Service Bulletin

Subject: Poor Horn Performance, Muffled and/or Not Loud

Brand:	Model:	Model Year:		VIN:		Engine:	Transmission:
		from	to	from	to		
Chevrolet	Volt	2016	2017

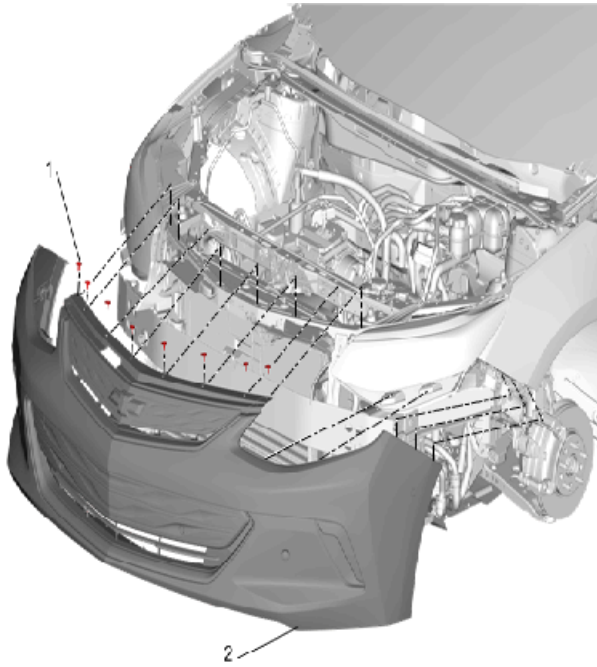
Condition	Some customers may comment that the vehicles horns are: <ul style="list-style-type: none"> • Performing poorly • Not loud • Muffled sound
Cause	This may be caused by the front wiring harness resting against the horn and bracket assembly causing them not to vibrate.

If the front wiring harness is found resting against the horns and/or bracket assembly, re-positioning of the wiring harness needs to be done to allow the horns to vibrate **without** interference.

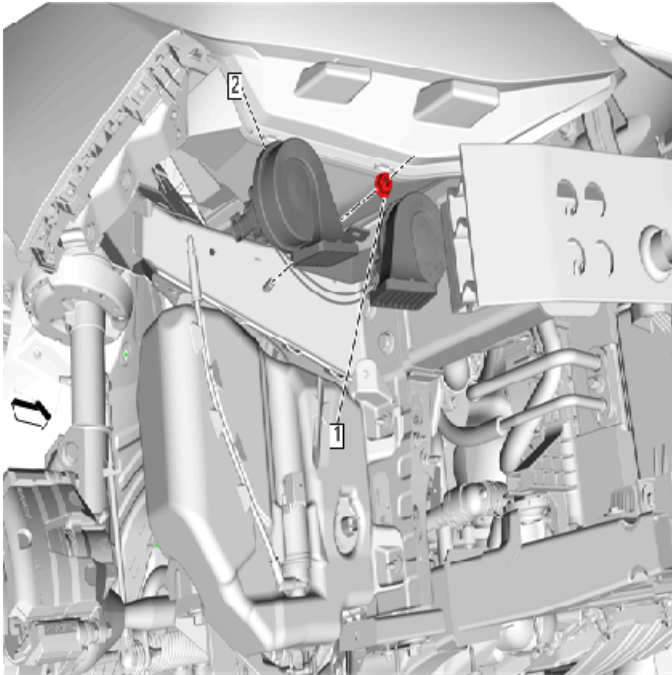
1. Remove the front bumper fascia (2). Refer to *Front Bumper Fascia Removal and Installation* in SI.

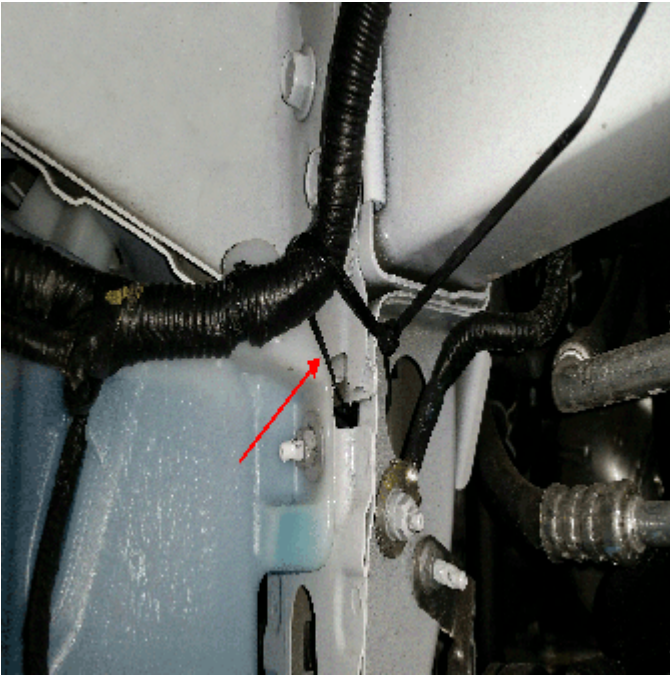
2. Disconnect the electrical connector at the low side horn (2).
3. Remove the nut (1) that secures the horn and bracket assembly to the frame and position aside.
4. Examine the wiring harness for any abnormal wear to the outer harness wrap and repair as necessary using Polyester Electrical/Anti-Abrasive Tape (PET) or equivalent anti-abrasion tape.

5. Using a tie strap, re-position the wiring harness away from the horn and secure the wiring harness to the frame as shown.

6. Using a tie strap, re-position the wiring harness away from the horn and secure the wiring harness to the frame as shown.
7. Install the horn and bracket assembly.

Tighten: the nut to 22 Y (16 lb ft).
